**WYOMING DEPARTMENT OF TRANSPORTATION**  
**QUARTERLY PROGRESS REPORT**

**Project title:** Pooled Fund for the Development of Approach Guardrail Transitions for Box Beam and MGS

**Project Number:** TPF-5(393)

### **MGS Transition Test Installation Drawings with Modified Transition Connection Plate**

Roadside Safety and Physical Security Division - Proving Ground	
Project #611801 5-6 Wyoming MGS Transition			2021-05-07
Drawn by GES\WS	Scale 1:12	Sheet 5 of 20	Transition Attachment

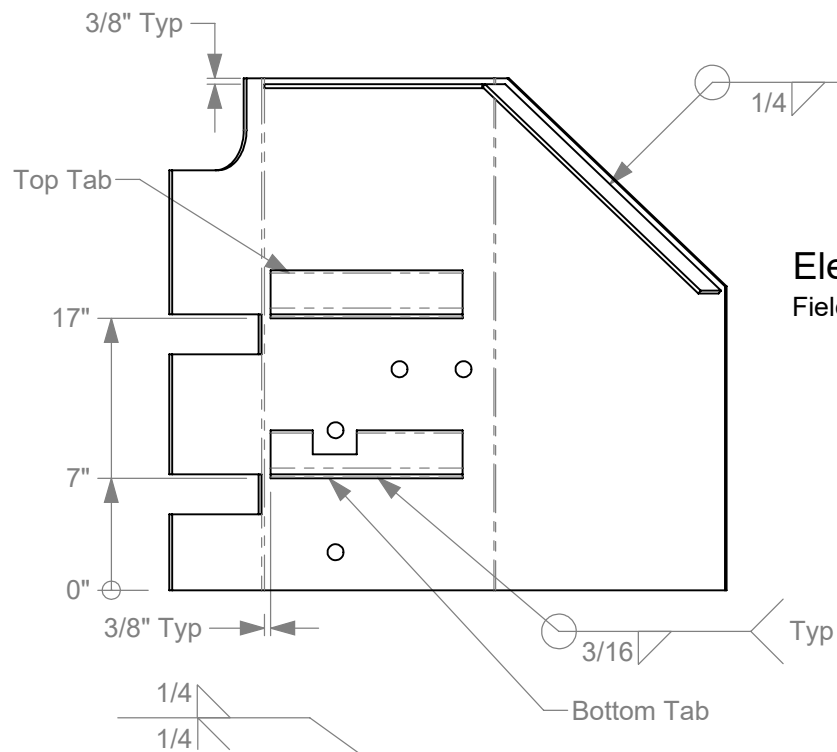
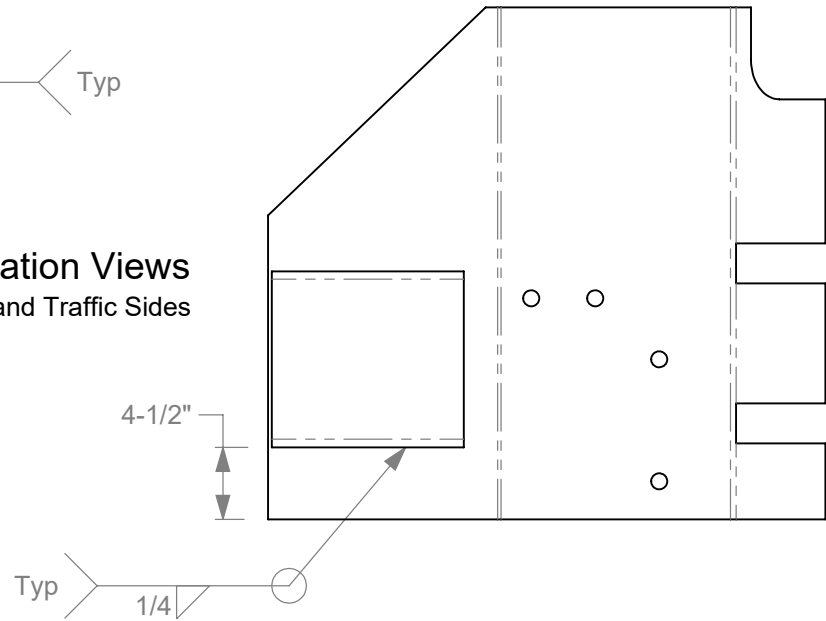
Work on Task 3 continued during the reporting period. The construction process has taken longer than anticipated due to delays in the state procurement process, material lead times required by the selected contractor, and a redesign of the transition connection plates that was required to provide needed construction tolerance.

The position of the transition connection plate was constrained by the C2P rail elements on the upstream end and the C2P post on the downstream end. There was no construction tolerance for small deviations in post placement. To incorporate reasonable field tolerance, some design changes to the transition connection plate are recommended. Note that these changes relate to the method in which the transition connection plate is attached to the C2P bridge rail and do not affect the shape or outward appearance of the initial design that was previously approved.

Rather than bolting tabs on the plate to the downstream flange of the first C2P post, angles are welded to the field side of the plate and the horizontal legs of the angles are bolted through the tubular rail elements. Slots in the angles provide tolerance for small differences in post placement due to anchor bolt position. Bent tabs on the downstream end of the plate are still present to mitigate snagging from the reverse direction, but the portion of the tabs that bolted to the C2P post is removed to provide the needed longitudinal tolerance for post placement, which is defined by the anchor bolts cast into the concrete curb. Revised drawings showing changes to the connection plate on the MGS transition are attached in Appendix A. Similar changes are proposed for the connection plate for the box beam transition.

The test installation drawings and test plan for evaluation of the box beam transition were previously submitted and approved. Revisions to the transition connection plate are recommended to provide needed in-field construction tolerance. The modified drawings are

being resubmitted to WyDOT for review and approval. If approved, the transition connection plates will be refabricated. The testing program will then be executed after completion of construction under Task 3.
